***RE: City of Venice Appeal Hearing 22-40SP***

***The Village at Laurel and Jacaranda Stormwater Responses to Appellant Comments***

### 6.3.5 UNIT HYDROGRAPHS AND PEAK RATE FACTORS

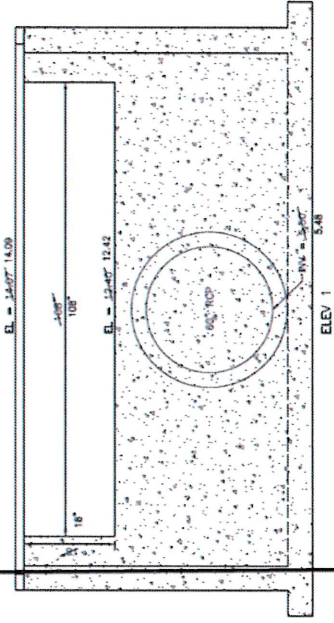
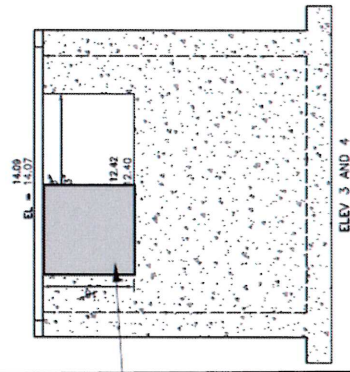
- 1) When calculating the flowrate of potential stormwater runoff from the project applicant's consultant used a peaking factor (a representation of the runoff from a rainfall event over time) generally used for flat, natural land with depressions providing areas for rainfall runoff to collect and slow down on its way to the pond. A more appropriate factor would have been one used for developed areas with

impervious surfaces and a storm drain system that will direct the rainfall to inlets and pipe it to the pond. The applicant's model assumed that rainfall from a storm will be slowed down on site, thus reducing the peak flow runoff rate. That is an assumption that should not have been made. When runoff gets to a pond faster the pond will fill up more quickly than if the runoff was coming at a slower rate that is spread out over a longer time period. (Under Section 87-3.3(c)(6) of the LDR, "Drainage calculations must be provided to verify that the peak flow rate and total volume do not exceed the pre-developed runoff." Those calculations should be accurate. The peak flow rate and the total volume for this project should be calculated using the appropriate peaking factor).

**RESPONSE: The model does not erroneously assume that rainfall from the site is slowed down. The peaking factors that were used in the model are consistent with what is required in the drainage watershed models prepared by Sarasota County. See attached exhibit labeled "unit hydrograph PRF" which is from the Sarasota County Storm water manual. As an attachment in this storm water manual (Attachment 10) a report prepared by Kimley Horn in 2005 also recommended using a peak rate factor of 100 for undeveloped conditions and 256 for developed conditions.**

The NRCS Unit Hydrograph approach must be used. A peaking factor of 100 must be used for basins in an undeveloped condition and a peaking factor of 256 must be used for basins in a developed condition. A mix of developed and undeveloped conditions may exist within the project area. Within ICPR4, the Uh256 unit hydrograph should be used with peaking factor 256, and the Uh100C unit hydrograph should be used with peaking factor 100. Attachment 11 provides additional unit hydrograph information.
